UNITED STATES PATENT AND TRADEMARK OFFICE

APPLICATION NO.	FILING DATE	FIRST NAMED INVENTOR	ATTORNEY DOCKET NO.	CONFIRMATION NO.
10/672,318	09/26/2003	Robert G. Rani	N-32720A/USN	8415
1095	7590	12/04/2006	EXAMINER NICOLAS, FREDERICK C	
NOVARTIS CORPORATE INTELLECTUAL PROPERTY ONE HEALTH PLAZA 104/3 EAST HANOVER, NJ 07936-1080			ART UNIT 3754

Office Action Summary

DETAILED ACTION

FIG. 3

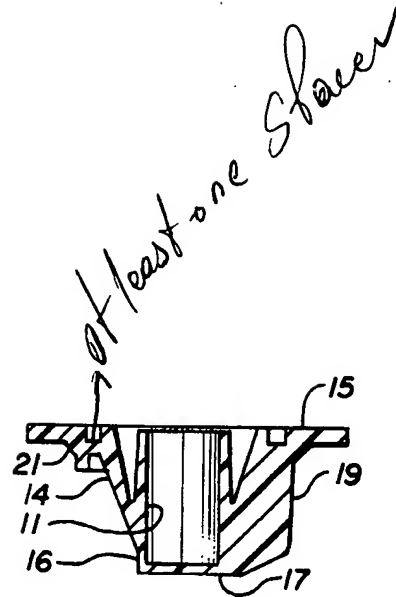
as seen in Figure 4, the cylindrical member adapted to allow the medical fluid to flow therethrough and exit the flexible container (col. 3, ll. 50-68 onto col. 4, ll. 1-2), a first seal (38) blocking the cylindrical member and capable of being breached, and a second seal (17) covering second opening and capable of being defeated, wherein a portion of the cylindrical member between the first seal and the second seal defines a chamber as seen in Figures 3-4, the first seal comprises a weakened section (35), a spike set (39), the base sealingly attached to an edge of the container as seen in Figure 7, the support further comprises a raised surface (see attached Figure 8 for location), at least one spacer (see Figure 3 for the location of one spacer), the at least one spacer comprises first and second wall members as seen in Figure 3, please note that the enclosure of the spacer forms the walls as seen in Figure 3.

FIG. 4

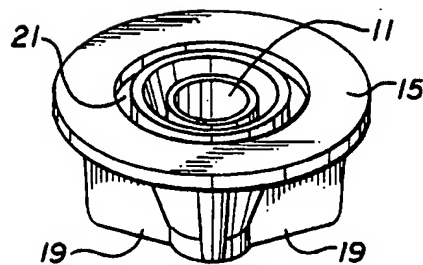
Larkin et al. disclose a closure device for a flexible container containing a medical fluid (col. 1, ll. 5-11), which comprises a boat-shaped base section (19) having a top wall (15), a bottom wall, the base section adapted, to fit the flexible container as seen in Figure 6, a mid-section (14) connected to the top wall, a support (21) with a wing (22) connected to the mid-section, a cylindrical member (11) extending through the base section, the mid-section and the support as seen in Figure 4, the cylindrical member having a first opening in the base section and a second opening in the support
